Thor Motor Coach Recall Repair Instructions

Recall #	19V-799 2019-560		
Description/Title:	Diesel Rear Reflector		
Affected Product Line(s):	Certain model 2013 through 2018 Tuscany, 2014 through 2017 Tuscany XTE and 2016 through 2020 Venetian motorhomes		
Service Campaign # :	RC000180	Released Date:	12/16/2019
Repair Code:	TMCRC80487V	Document Date:	12/16/2019
Time Allowed:	0.10	Document Revision:	A

Figure 1

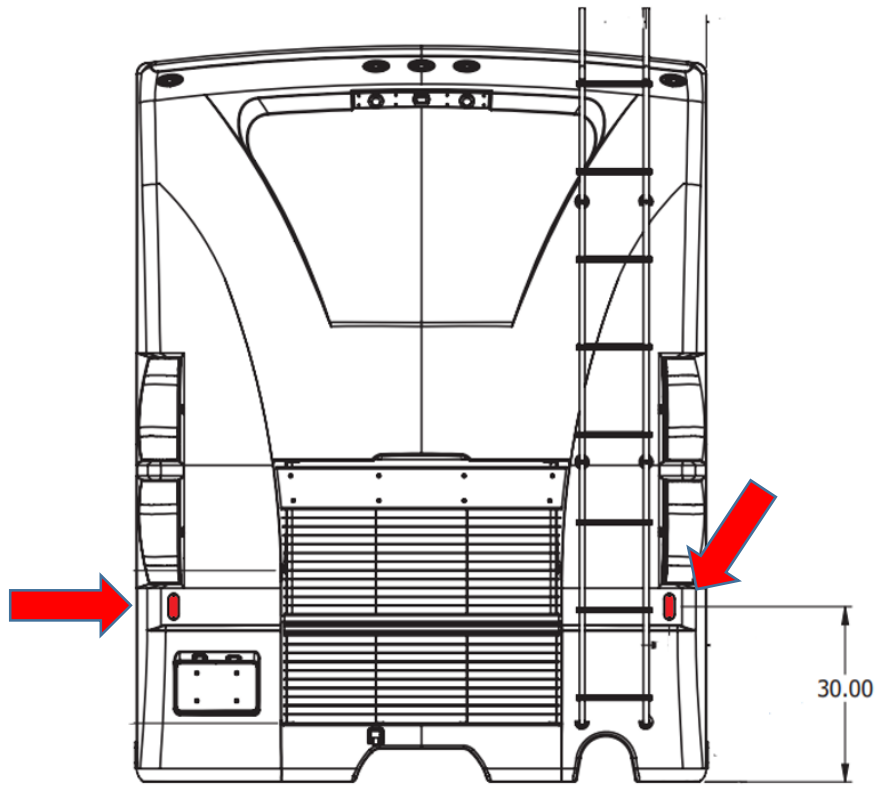
On certain model 2013 through 2018 Tuscany, 2014 through 2017 Tuscany XTE and 2016 through 2020 Venetian motorhomes, the rear reflectors are not in the proper position per FMVSS 108.

1. Clean area of rear cap so it is free of dirt and debris.
2. On the rear of the coach, measure 30" up from the bottom of the rear cap as depicted in Figure 1 on both sides of the rear cap.
3. After measuring, place one adhesive reflector on each side of the rear cap which should be just under the taillight lens as depicted in Figure 2.
4. On the side, from the bottom of the rear cap, measure up 6" and place one adhesive reflector on each side of the rear cap and align it with the trim molding as depicted in Figure 2.
